City of Alachua

Planning & Community Development Department Staff Report

SUBJECT: A request for a Site Plan for the construction of a ±13,330 square foot building and a ±11,750 square foot building, with associated parking, stormwater, utilities, and supporting site improvements

EXHIBIT "A"
TO
COPELAND PARK – PHASE 1
SITE PLAN
STAFF REPORT

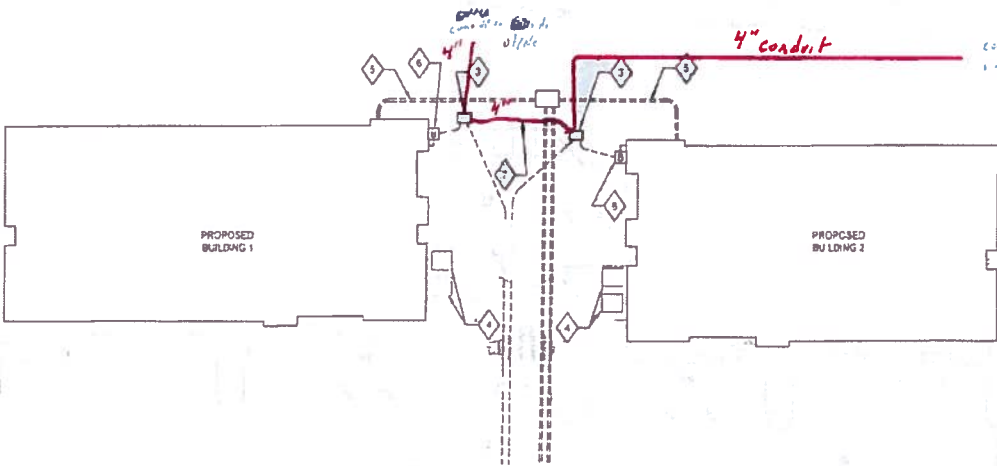
7.	<p><u>Electrical Site Plan</u>; Sheet E101</p> <p>Primary electric will serve transformers from existing overhead north of proposed building 1 and building 2.</p> <p>COUNTY ROAD 2054 / RACHAEL BLVD</p>  <p>[Revise and Resubmit]</p> <p>Response: the electrical design has been revised accordingly. Please see the revised Site Electrical Plan, sheet E101.</p> <p>Comment: Provide 4-inch conduit not shown on resubmittal from transformer B back to existing. Reference illustration above.</p> <p>[Approved as Noted]</p>

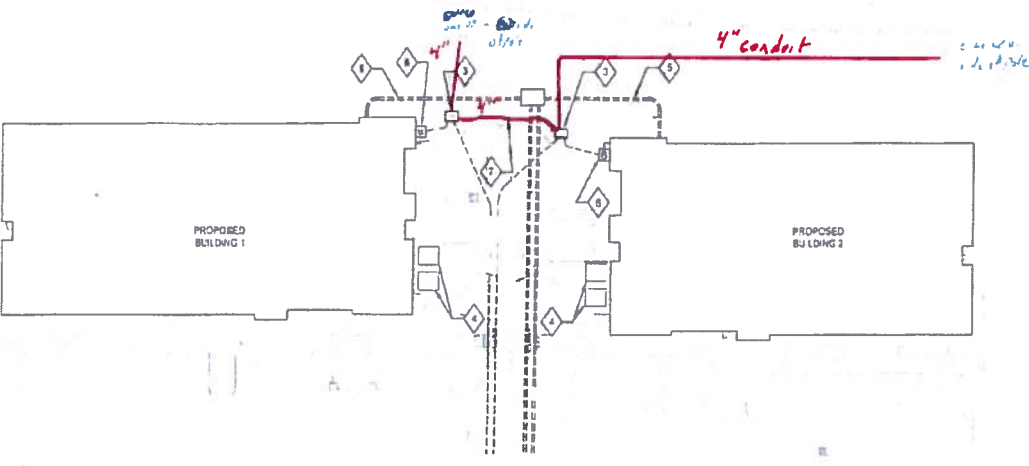
NO.	COMMENTS
5.	<u>Pipe Fittings; Sheet C3.10</u> Cross fitting are not acceptable. [Revise and Resubmit]
7.	<u>Electrical Site Plan; Sheet E101</u> Primary electric will serve transformers from existing overhead north of proposed buildings; as shown in RED . <div style="text-align: center;"> COUNTY ROAD 2054 / RACHAEL BLVD </div>  <p>[Revise and Resubmit]</p>

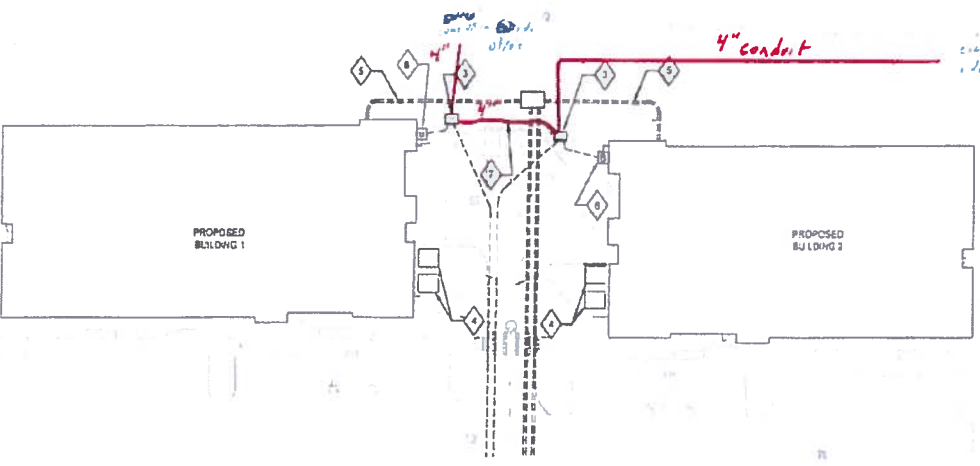
NO.	COMMENTS
5.	<p><u>Pipe Fittings</u>; Sheet C3.10</p> <p>Cross fitting are not acceptable.</p> <p>[Revise and Resubmit]</p>
	<p><u>Electrical Site Plan</u>; Sheet E101</p> <p>Primary electric will serve transformers from existing overhead north of proposed buildings; as shown in RED.</p> <p>COUNTY ROAD 2054 / RACHAEL BLVD</p>  <p>[Revise and Resubmit]</p>

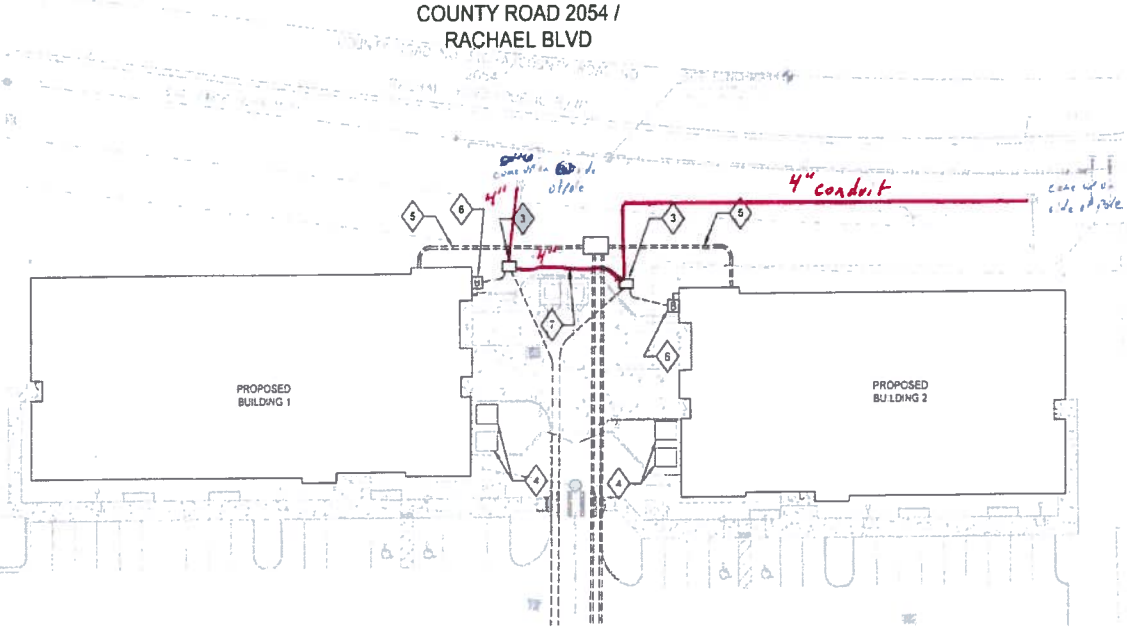
NO.	COMMENTS
5.	<u>Pipe Fittings</u> ; Sheet C3.10 Cross fitting are not acceptable. [Revise and Resubmit]
7.	<u>Electrical Site Plan</u> ; Sheet E101 Primary electric will serve transformers from existing overhead north of proposed buildings; as shown in RED .  [Revise and Resubmit]
